CONTRACT CHANGE ORDER NO. ____
SHEET ___ OF ___

MARK	DATE	DESCRIPTIONS	BY	CH'D	CCO#
		REVISIONS			
1	07/31/09	LONGITUDINAL SHEAR PLATE	DT	GB	122

SAN FRANCISCO OAKLAND BAY BRIDGE
EAST SPAN SEISMIC SAFETY PROJECT
SELF-ANCHORED SUSPENSION BRIDGE
(SUPERSTRUCTURE & TOWER)

GIRDER AT EAST TRANSITION NO. 15

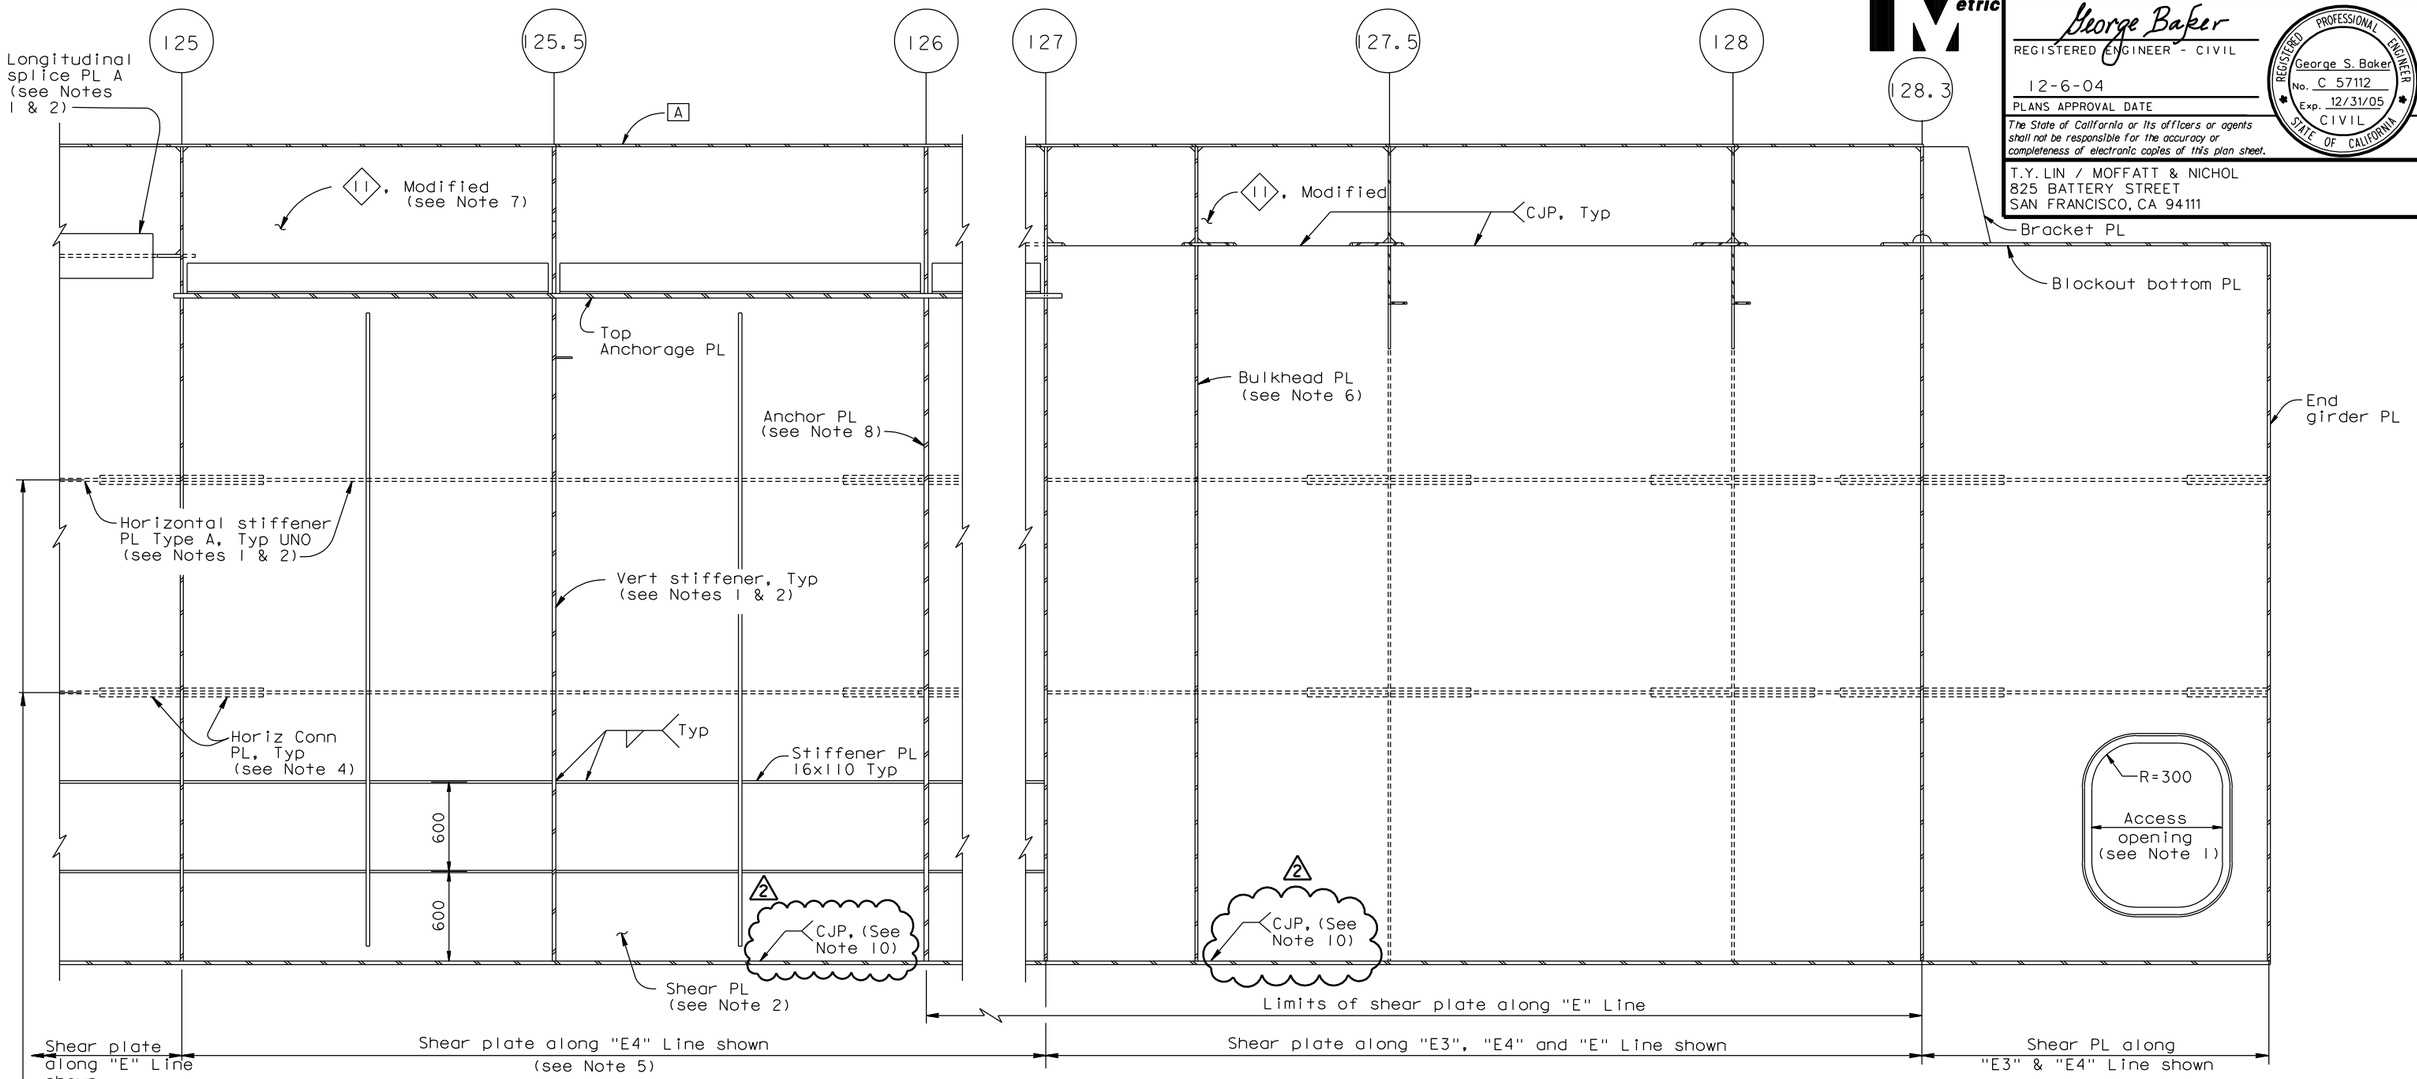
2. 10. The Longitudinal Shear Plate to Girder Face "D" weld shall be a CJP from the CL Splice near PP111 to PP128.7.

MARK	DATE	REVISIONS	BY	CH'D	CCO#
2	07/31/09	LONGITUDINAL SHEAR PLATE	DT	GB	122
1	07/30/07	HINGE A REACTION-SHEAR PLATES	DT	GB	50

GIRDER AT EAST TRANSITION NO. 16

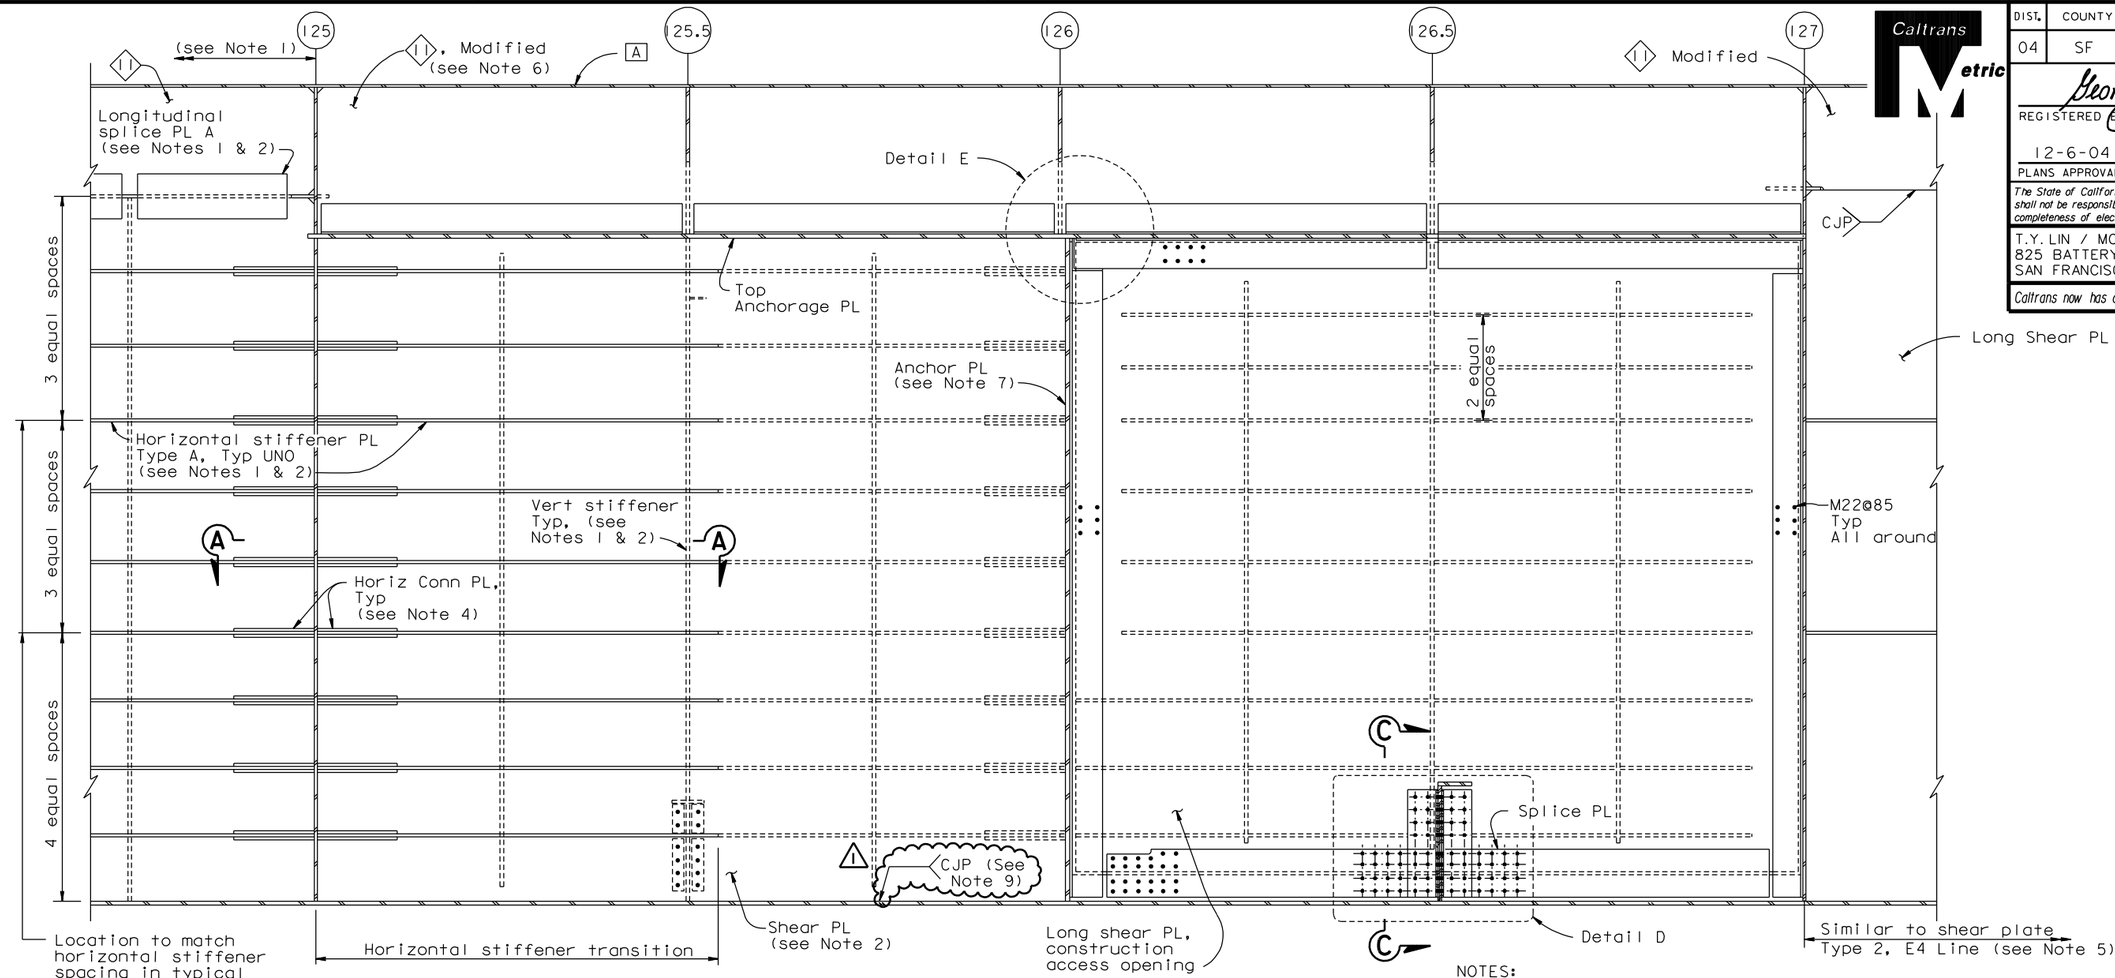
8. For Sections A-A, C-C and Details D and E, see "Girder At East Transition Details No.4" sheet.
9. The Longitudinal Shear Plate to Girder Face "D" weld shall be a CJP from the CL Splice near PP111 to PP128.7.

MARK	DATE	DESCRIPTIONS	BY	CH'D	CCO#
1	07/31/09	LONGITUDINAL SHEAR PLATE	DT	GB	122

GIRDER AT EAST TRANSITION DETAILS NO. 4

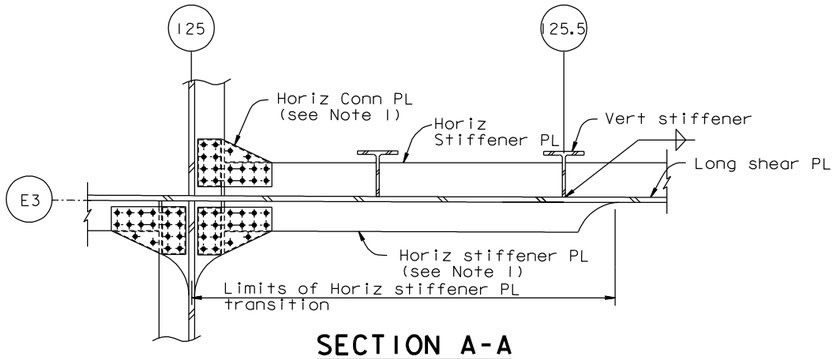
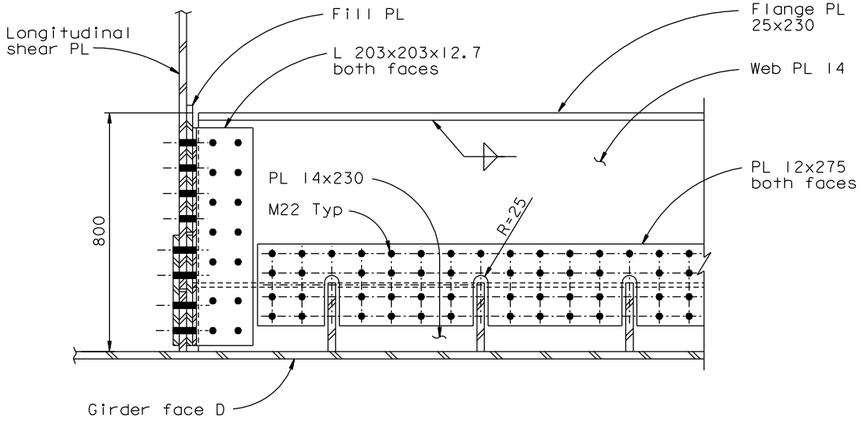
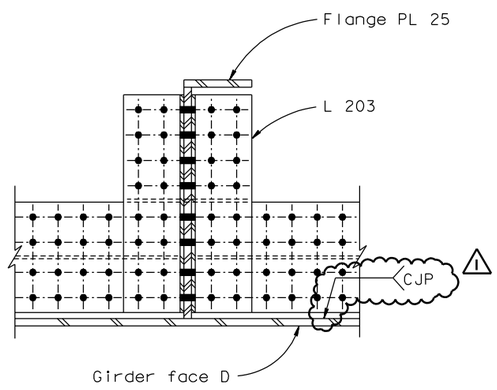
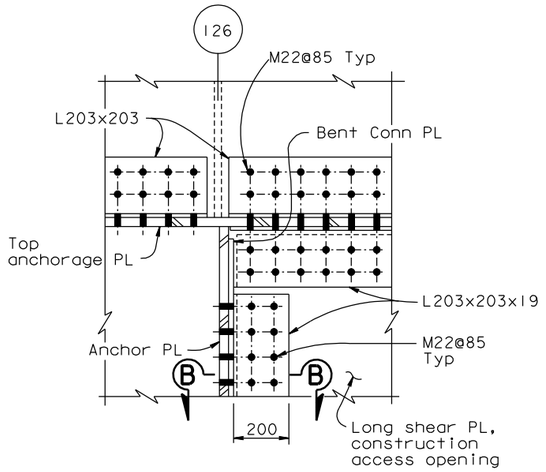
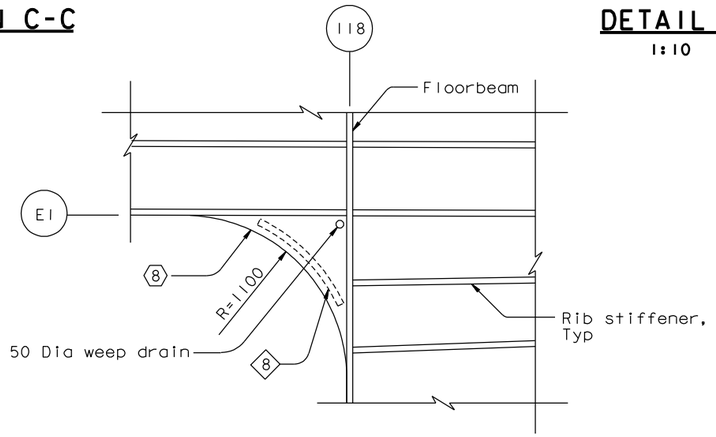
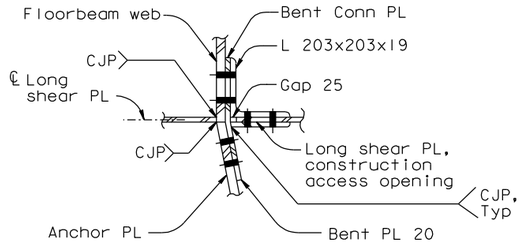
MARK	DATE	DESCRIPTIONS	BY	CH'D	CCO#
1	07/31/09	LONGITUDINAL SHEAR PLATE	DT	GB	122
